Houston Lighting & Power

December 22, 1987
ST-HL-AE-2444
File No.: G9.17, J47, G9.1
10CFR50.62

South Texas Project Electric Generating Station
Units 1 and 2
Docket Nos. STN 50-498 and STN 50-499
Additional Information Concerning AMSAC

ADDITIONAL AMSAC INFORMATION

Figure 7.8-2 SHEET 1 Amendment

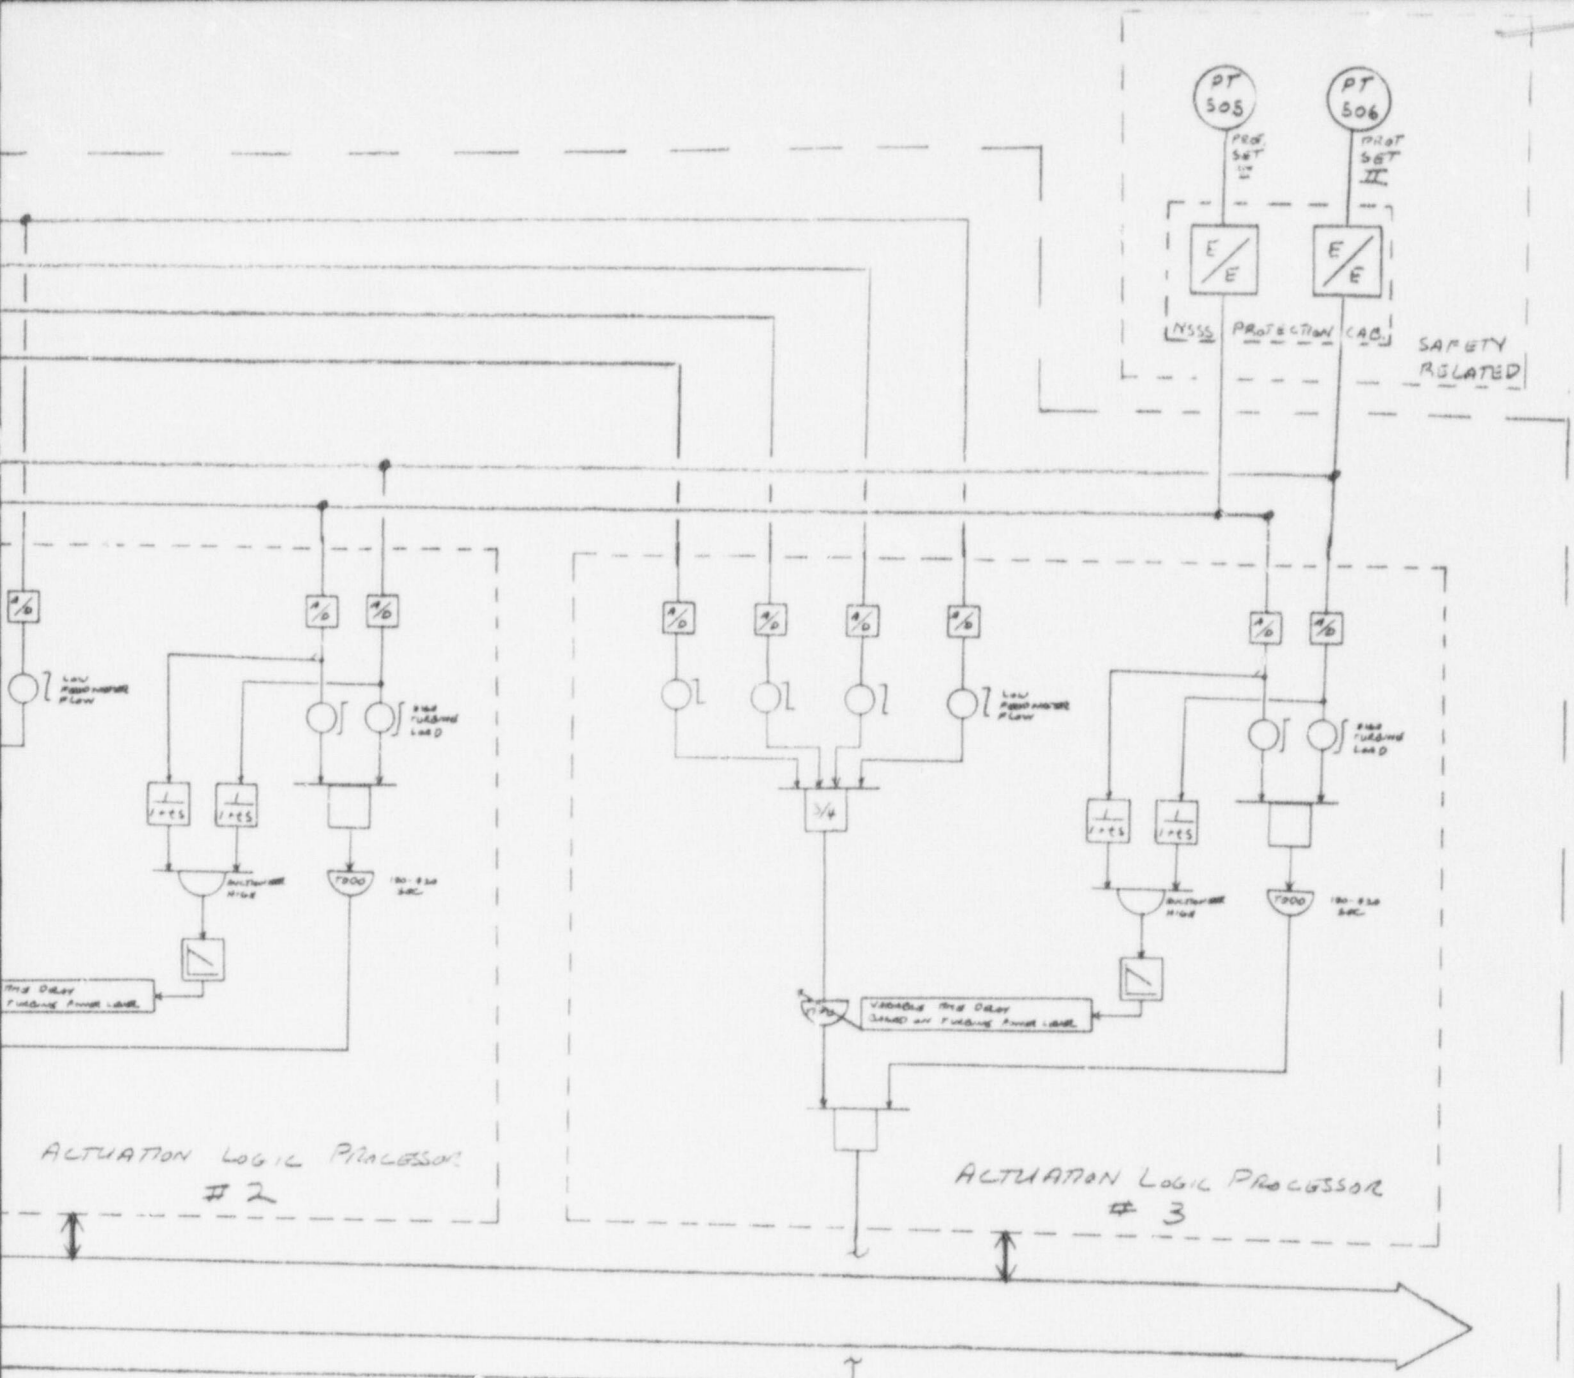
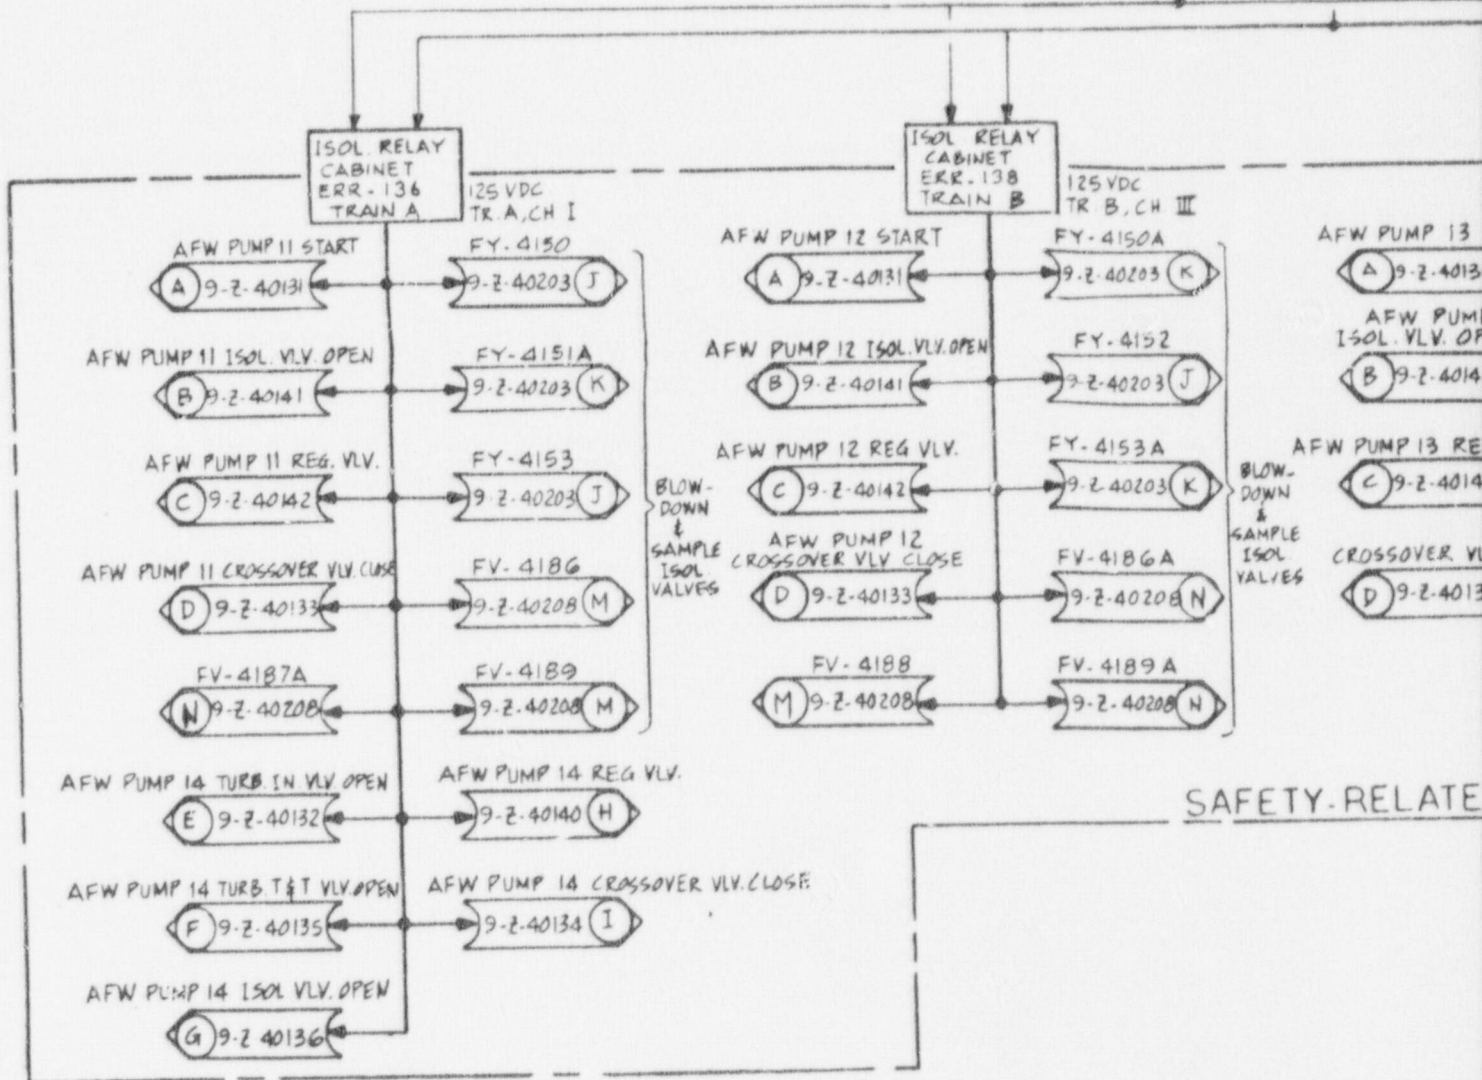
Provide a composite logic figure in the FSAR to show all inputs, outputs, and the location of logic functions, time delays, and isolation devices in the overall system.

A composite logic is provided as Figure 7.8-2 in Attachment 2.
